Service Bulletin UPDATE

Bulletin No: JC-13-23 Rev 2

Product Type: STEINER 440

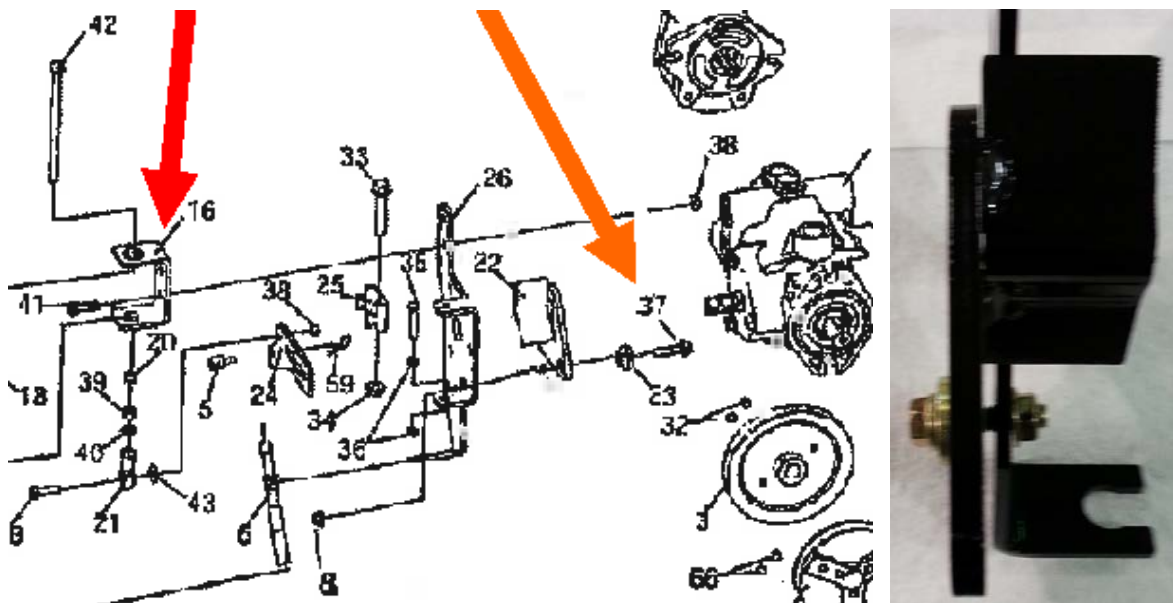
- 2. Neutralize the hydraulics and set proper F & R pedal movement to reach desired speeds.
 - 3. The neutral lock pivot bolt item 37 (orange arrow) must be installed as shown in the picture below.

- 4. Some of the tractors will have a backup beeper switch bracket that was installed at the factory. When replacing item # 16 (Red Arrow) neutralizing spring bracket, the backup beeper switch bracket (not shown) will be loose and can be removed if the tractor does not have the beeper kit installed.

- A. Remove the old F & R cable 128089-05 and 4168556-01.
 - 1. Order kit number 970485 and install all the new F & R linkage into the tractor including the new F & R cable 4169556. Refer to Directions in the kit. **NEW: The kit instructions did not include torque specification of 25 ft. lbs. of torque required for the pump lever bracket assembly; for details see page 6, line item 33 of the work instructions (4169598).**
